Final plat
SUBDIVISION REPORT

Name: Thunderbird 3rd Addition

Re: S/D 84-78 - Final plat of Thunderbird Addition

Re: S/D-84-78 - Final plat of Thunderbird Third Addition

FINAL PLAT

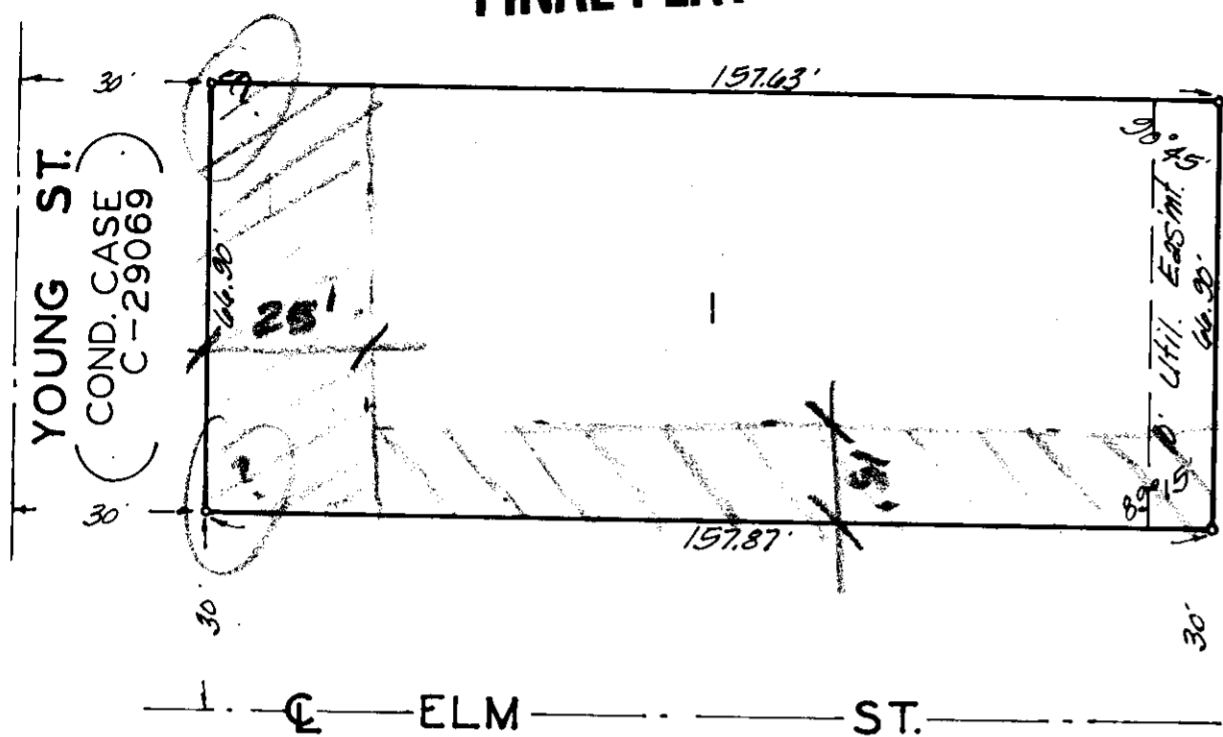
- A. The final plat tracing shall indicate a 25-foot setback on Young Street and a 15-foot setback on Elm Street.
- B. The representative from City Engineering should be prepared to comment on the availability of existing sewer for the site.
- C. The final plat tracing shall indicate appropriate angles for the north-west and southwest corner of the lot.
- D. The final plat tracing shall reference a tie to a platted lot corner or section corner.
- E. Closure computations shall be submitted with the final plat tracing.
- F. Recording of the plat within 30 days after approval by the Board of City Commissioners.

- ~~A.~~ The final plat tracing shall indicate a 25-foot setback on Young Street and a 15-foot setback on Elm Street.
- ~~B.~~ The final plat tracing shall indicate appropriate angles for the northwest and southwest corner of the lot.
- ~~C.~~ The final plat tracing shall reference a tie to a platted lot corner or section corner.
- ~~D.~~ Closure computations shall be submitted with the final plat tracing.
- ~~E.~~ Recording of the plat within 30 days after approval by the Board of City Commissioners.
